Clarification Memorandum to File

RE: Auburn Road Landfill Superfund Site
Clarification of Site Boundary & Operable Units in Five Year Reviews

Auburn Road Landfill Superfund Site

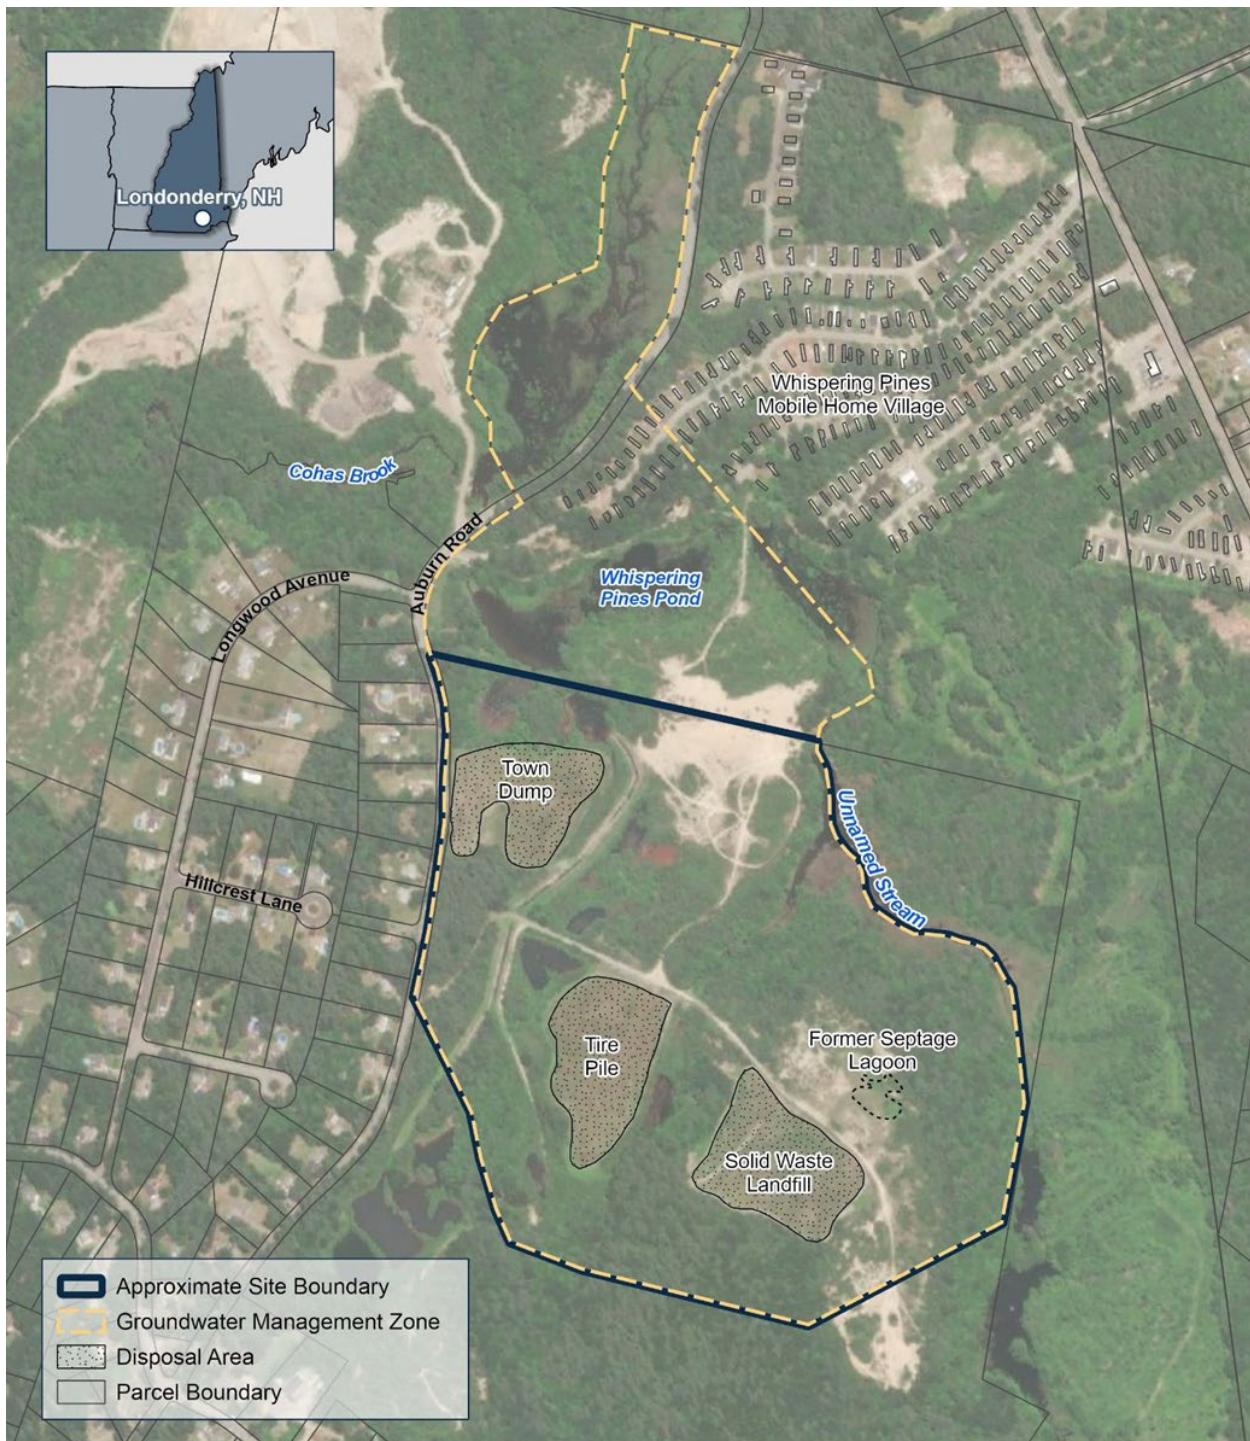
In the recent Seventh Five Year Review (FYR) Report completed on September 12, 2022, the Site boundary was described as the portion of the NHDES Groundwater Management Zone (GMZ) that abuts the property owned by Mr. Al Simard. Figure 1 of the 7th FYR Report shows this approximate Site boundary with a black solid line (Refer to figure attached). However, the historical data for all monitoring wells reveals that various monitoring wells within Mr. Simard's property have shown arsenic concentrations that exceed both the EPA cleanup level (10 µg/L) and the NHDES Ambient Groundwater Quality Standard (5 µg/L). The data review performed as part of the 7th FYR showed that from 2017 to 2022, arsenic exceeded the cleanup goal (10 µg/L) at 25 monitoring locations including 15 overburden wells, 7 bedrock wells and 3 piezometers, located throughout the entire GMZ. Detected concentrations ranged from 5 µg/L in bedrock monitoring wells MW-1A and MW-108A to 234 µg/L in overburden monitoring well NUS-1-2, which lies in Mr. Simard's property. Please refer to Figure D-4 and Figure D-5 of the 7th FYR Report showing the 2021 arsenic concentrations in overburden and bedrock groundwater.

Groundwater contamination remains generally contained within the GMZ, except for well MW-210. Well MW-210 is located immediately outside and downgradient from the GMZ boundary on the north side of Cohas Brook (refer to Figure 2 of the 7th FYR Report). This well consists of an overburden/bedrock couplet. At this couplet's bedrock well (MW-210A) arsenic was detected in fall 2021 at a concentration of 10 ug/L, which is equal to the site cleanup goal. Previous results from this well have ranged from non-detect (less than 5 µg/L) to 11 µg/L (observed in 2018).

As a result of the above data, it is necessary to extend the Site boundary to include the entire area within the GMZ including the portion of Mr. Simard's property inside the GMZ.
